**Deadline 7 Submissions**  
**Preston Farms Ltd ("PFL") and TCS Biosciences Ltd ("TCS")**

## Rosefield DCO Application examination

### Deadline 7 (final deadline) submissions/evidence of Preston Farms Limited (PFL) and TCS Biosciences Limited (TCS)

# Rosefield Solar Farm

Version 2 - E23 No Solar with access moved east

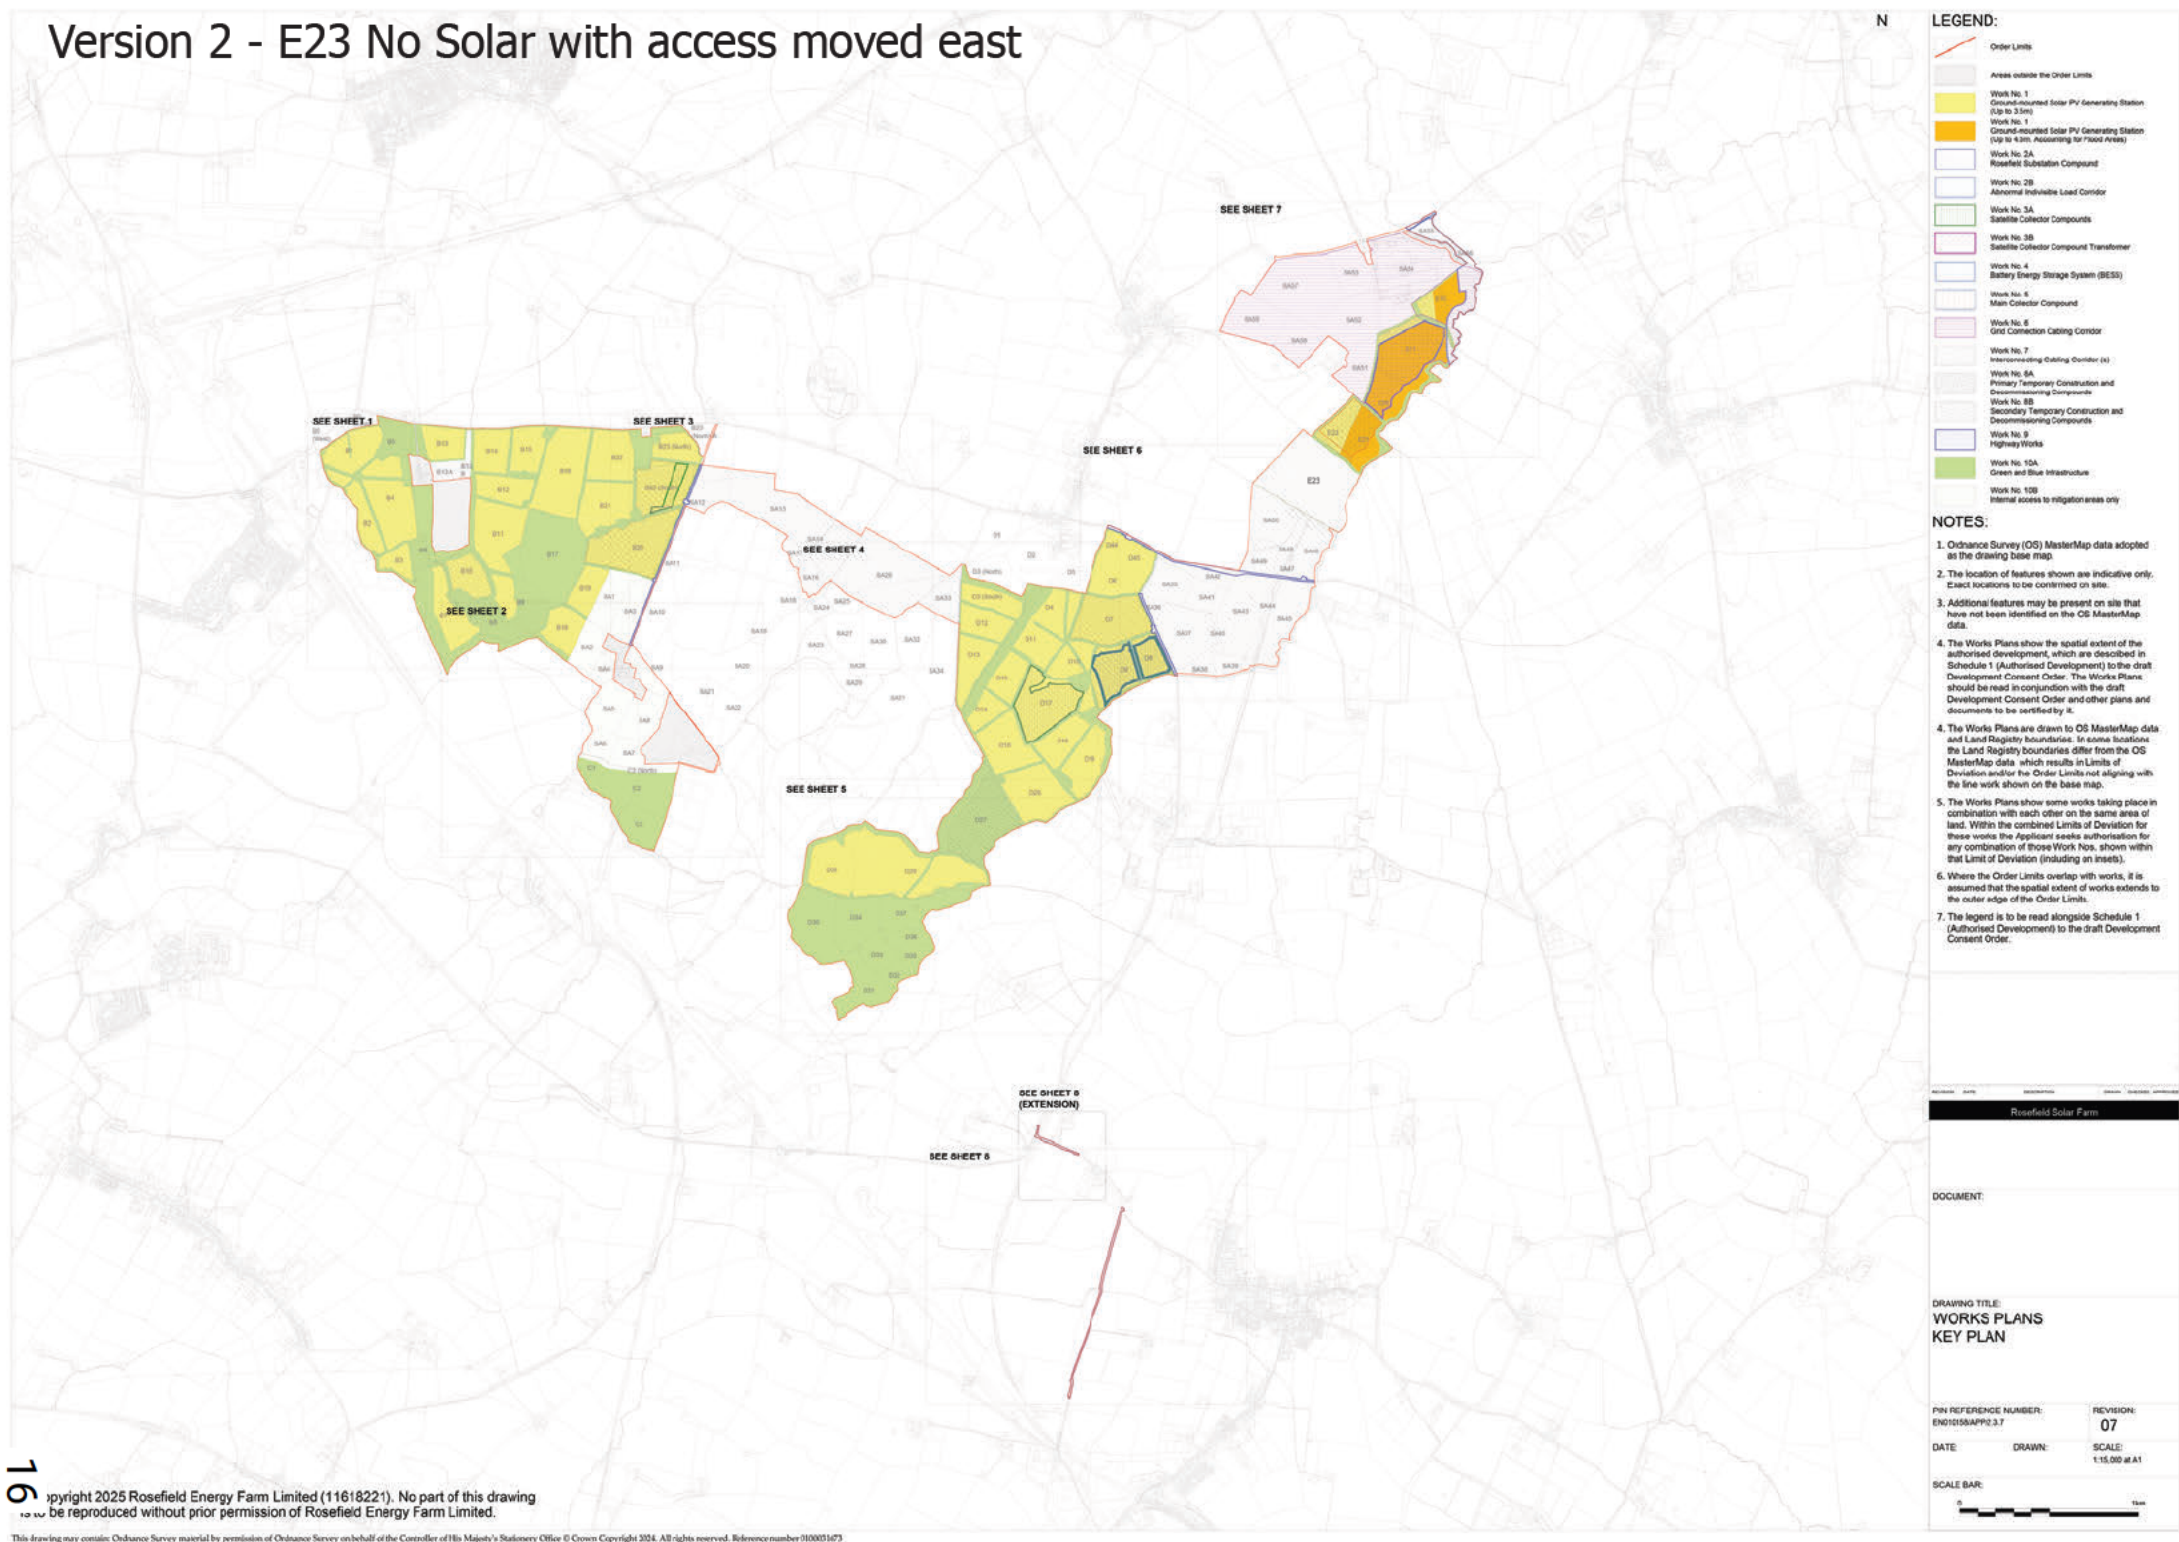
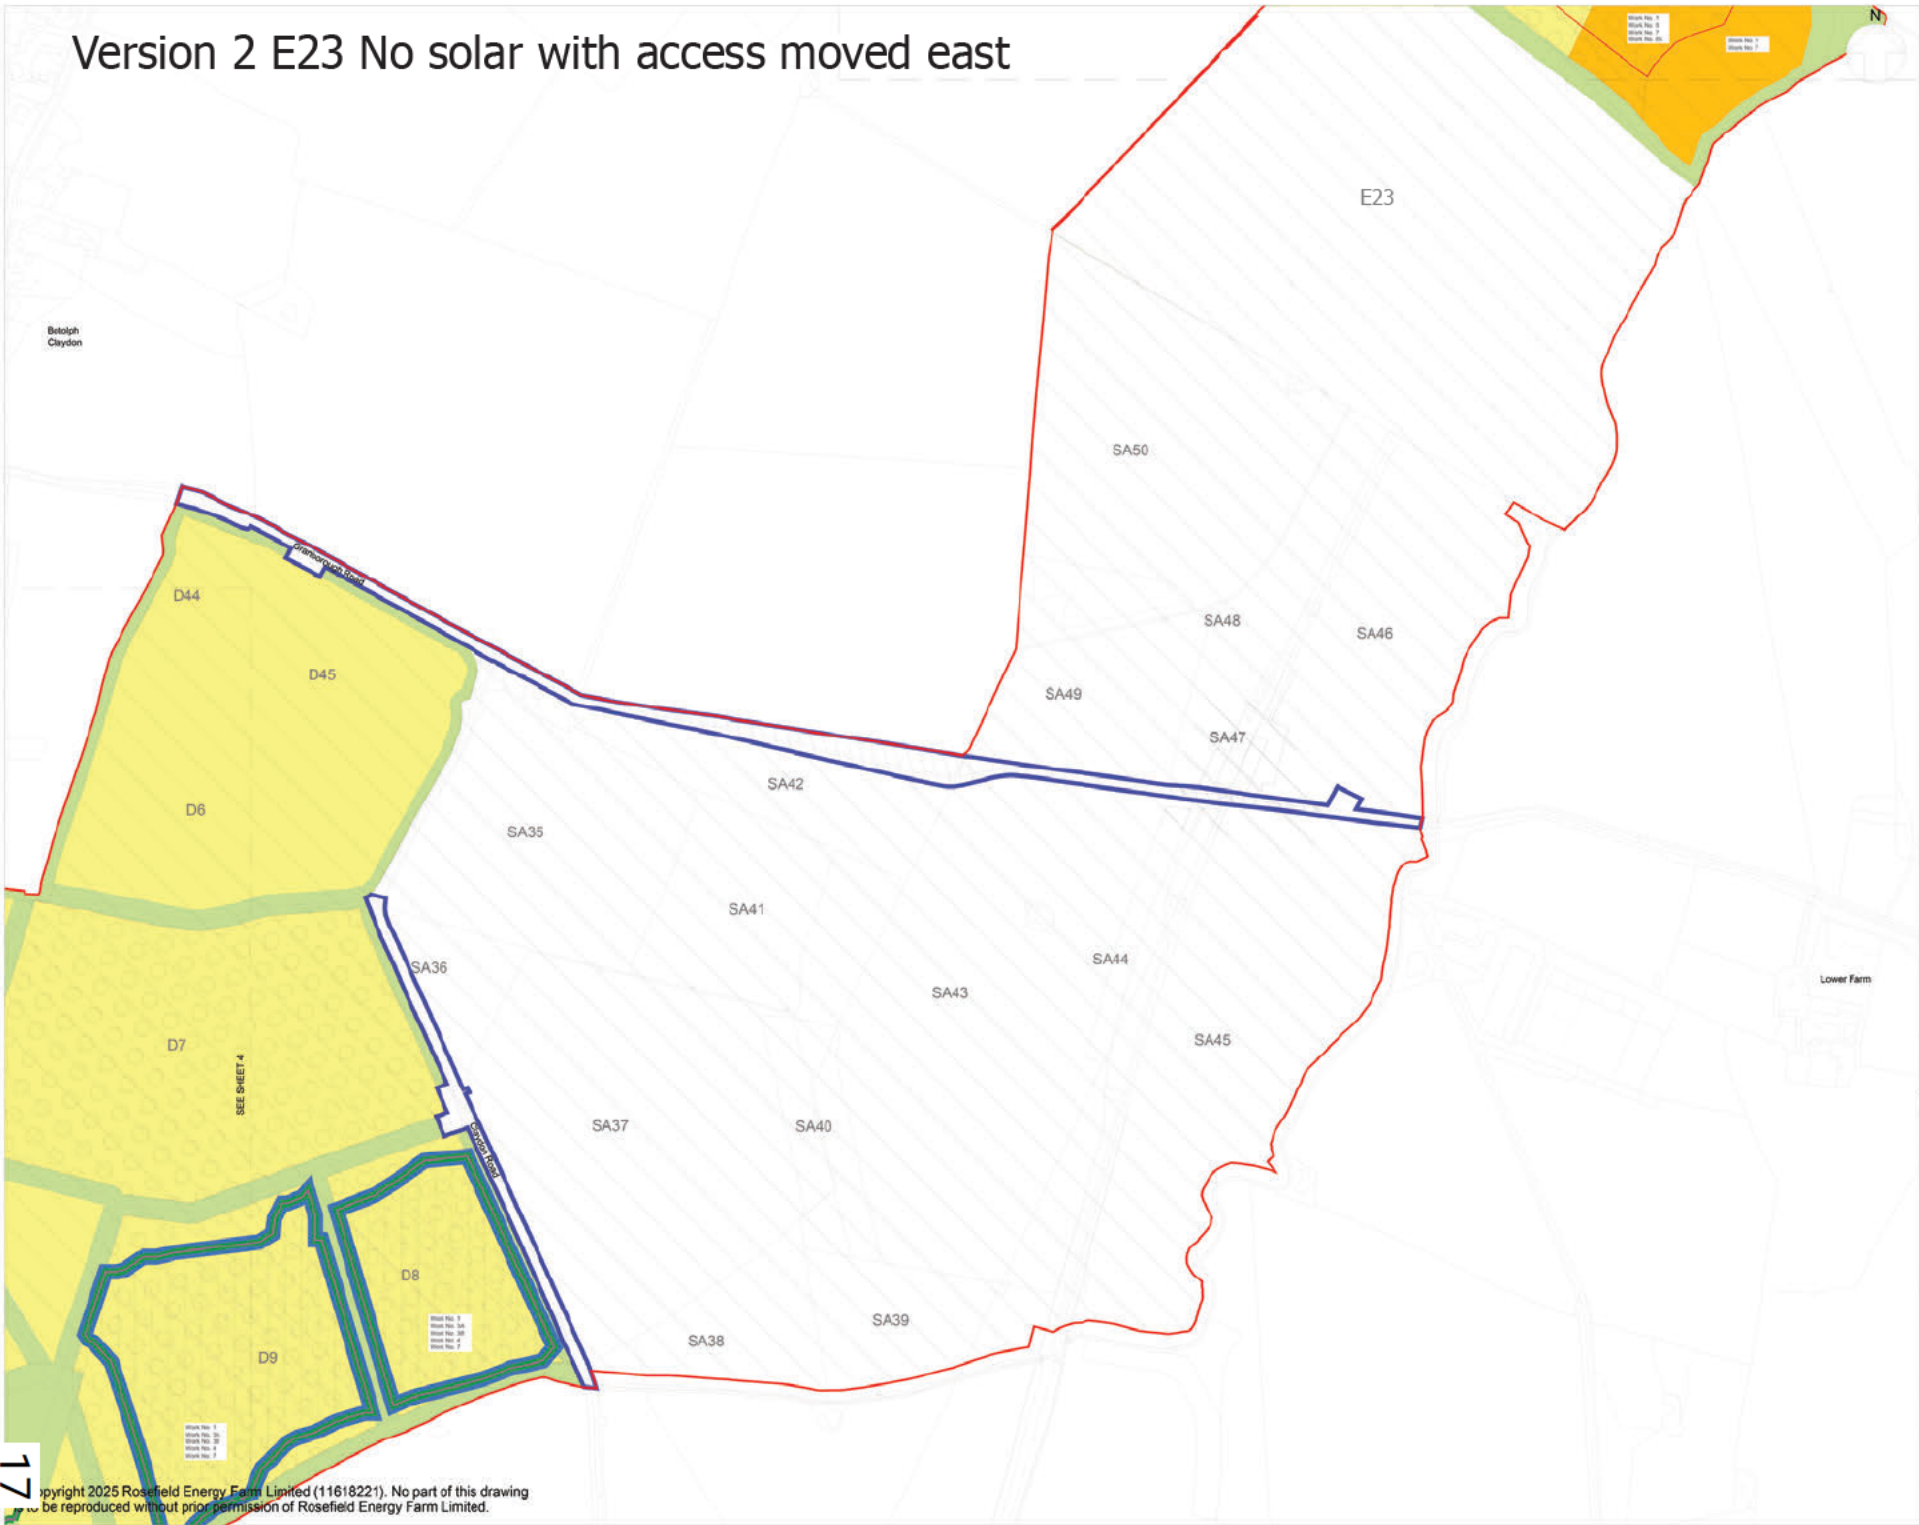
34. If, contrary to PFL/TCS' case, there is to be a Granborough Road access, for construction or operation, then it must be moved as far eastwards in field SA46 as possible. The Applicant was to speak to Buckinghamshire Council regarding visibility splays (PFL/TCS know the road very well and are convinced visibility would not prevent a movement eastwards). There is still no explanation from the Applicant of its vague references to 'environmental' or 'ecological' constraint regarding the brook: the Works plans show separation from the brook already, and that is surely sufficient (the Applicant does not suggest the brook has any particular designated status of relevance).

36. Necessary modifications to the Works plans and to the draft DCO are attached. The modifications to the Works plans show, first, PFL/TCS' primary position, with no access off the Granborough Road (labelled "Version 1)", and, second, PFL/TCS' secondary position, with access off the Granborough Road but moved to the east (still with ample separation from the brook) (labelled "Version 2").

PFL / TCS edit with access an track moved further east

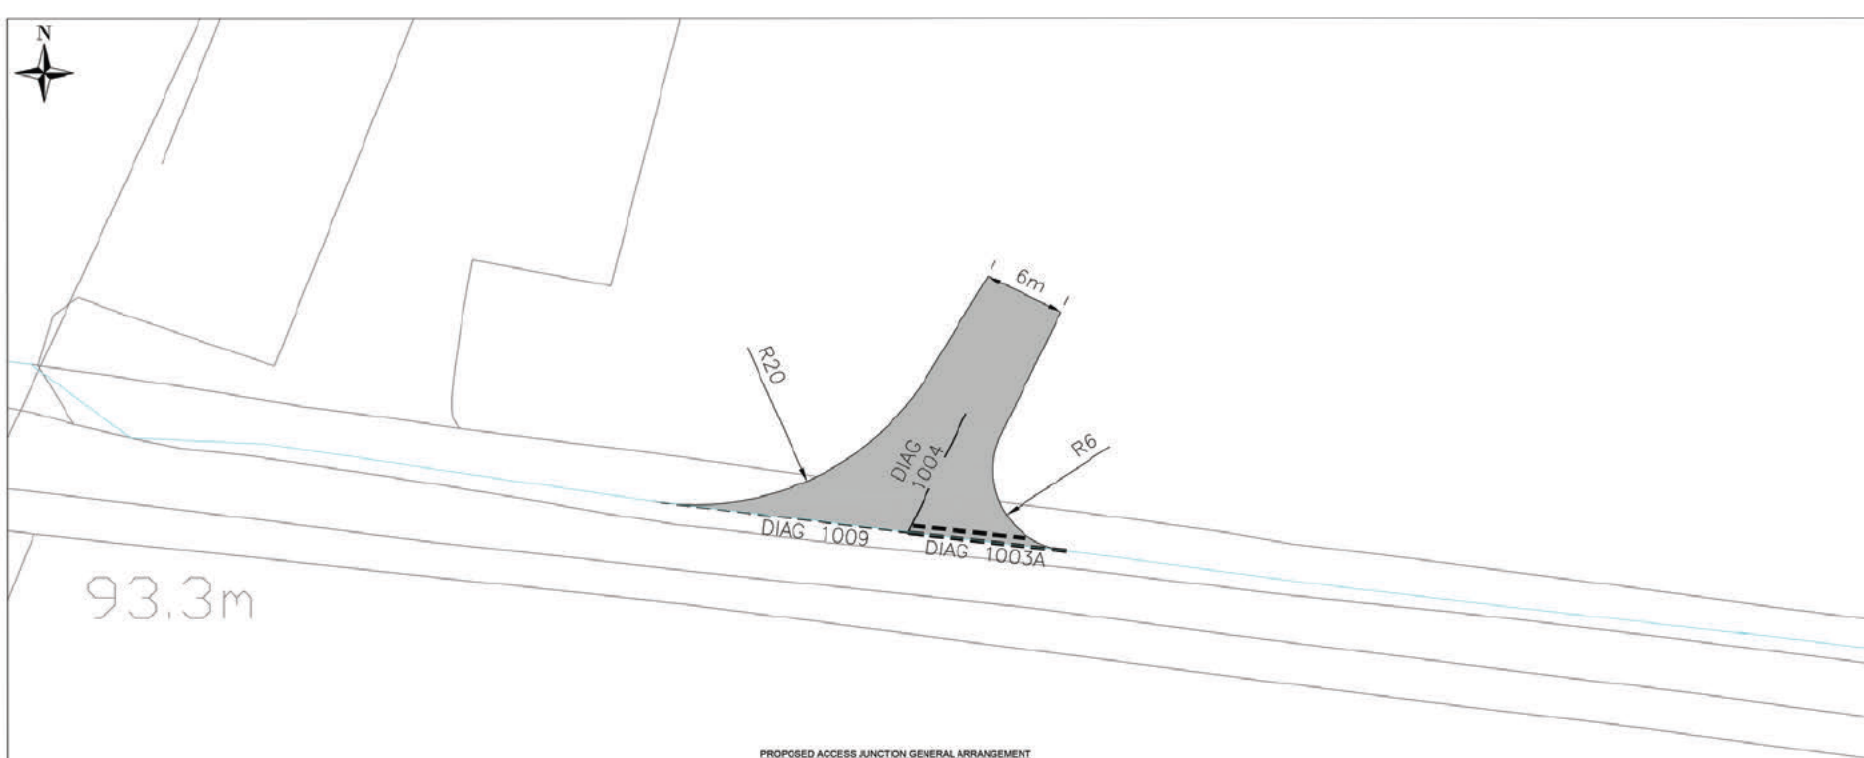
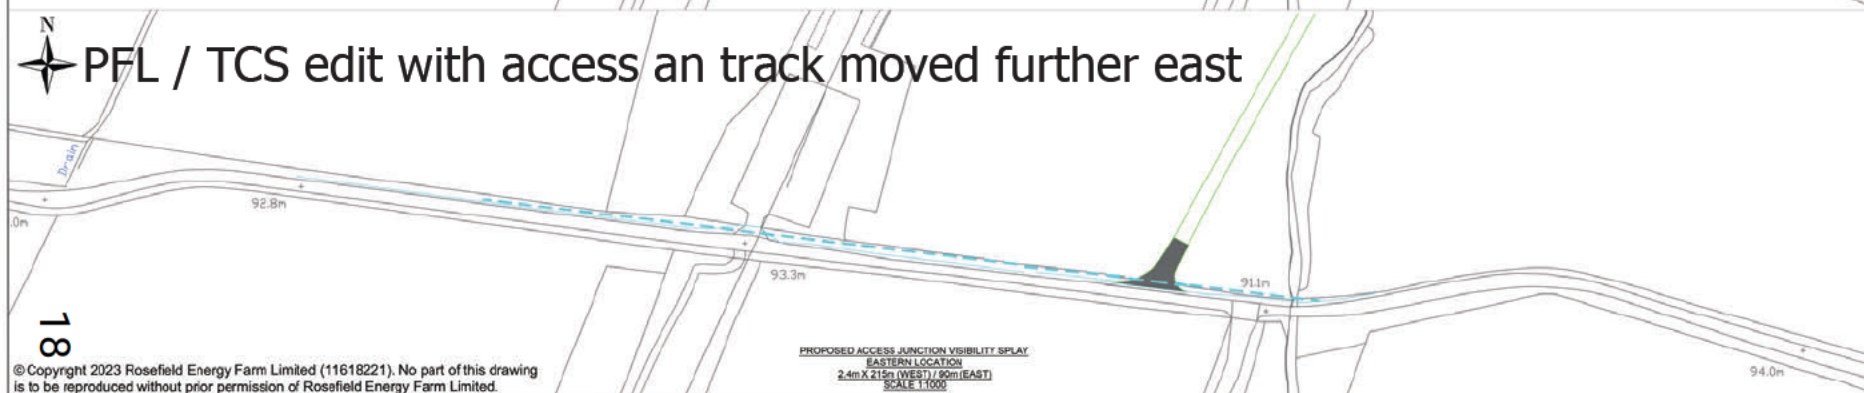
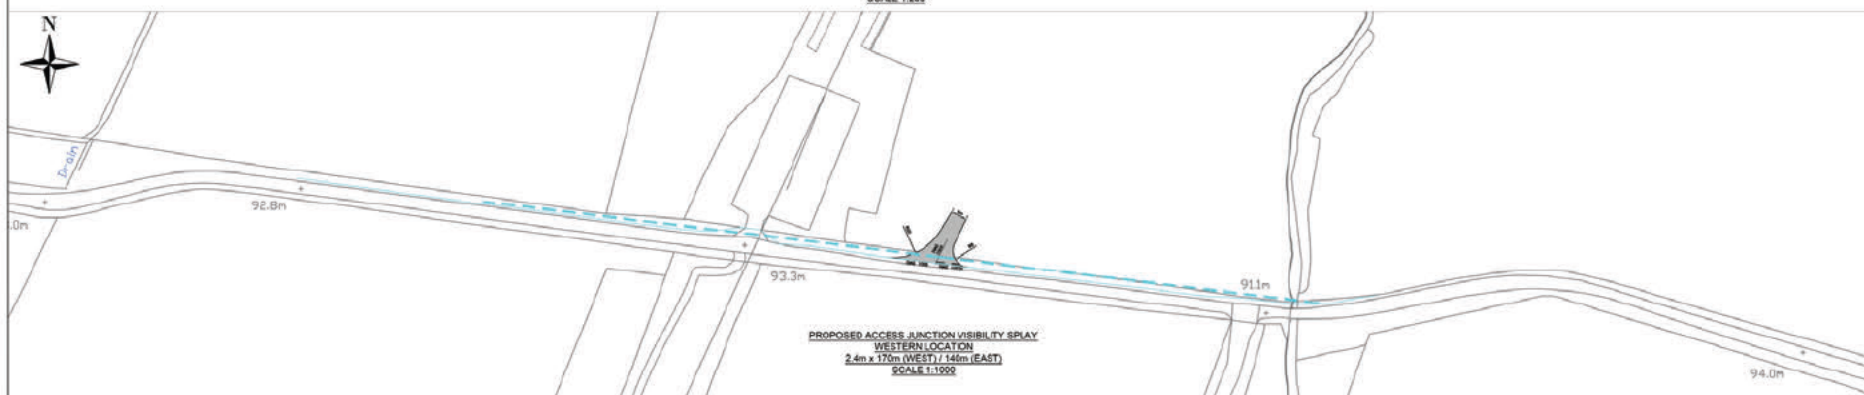
- iii. Page 44 of the CTMP adjusted by PFL/TCS shifting Granborough Rd access east
  - iv. Further correspondence from BIVDA dated 20 August 2026
  - v. DHSC Email (referred to in the BIVDA letter) (with presentation pack and mapping)

4. Regrettably, and although the Applicant has made some further incremental concessions (all of which are welcome), what stands out is how far short they fall of what statute and guidance requires.
